## L4450A-01

# S E R V I C E N O T E

## L4450A 64-Bit Digital I/O with Memory and Counter

Instrument cannot operate in 400 Hz

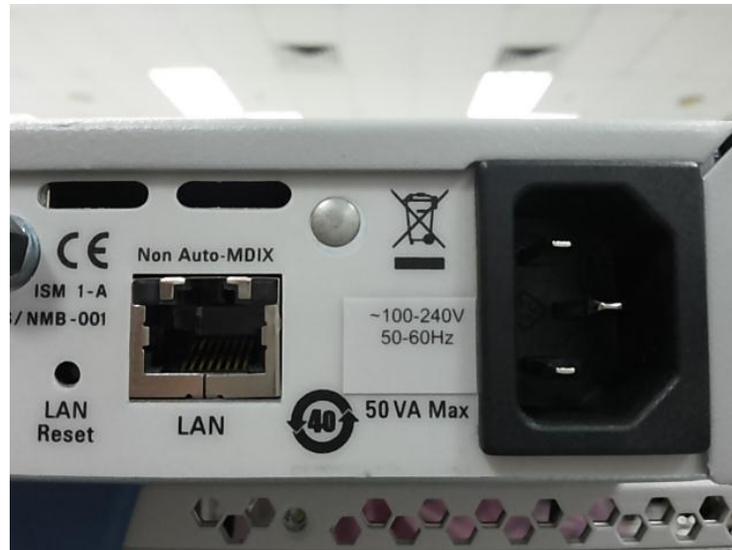
It has been found that the instruments with affected serial numbers listed above have incorrect information printed on the power rating label. The instrument does NOT support 400 Hz operation at 100-127V.

Order a L4421-84303 L44xxA Power Rating Label and apply it over the existing power rating information on the instrument. After applying the L4421-84303 label, it should look similar to the picture below.
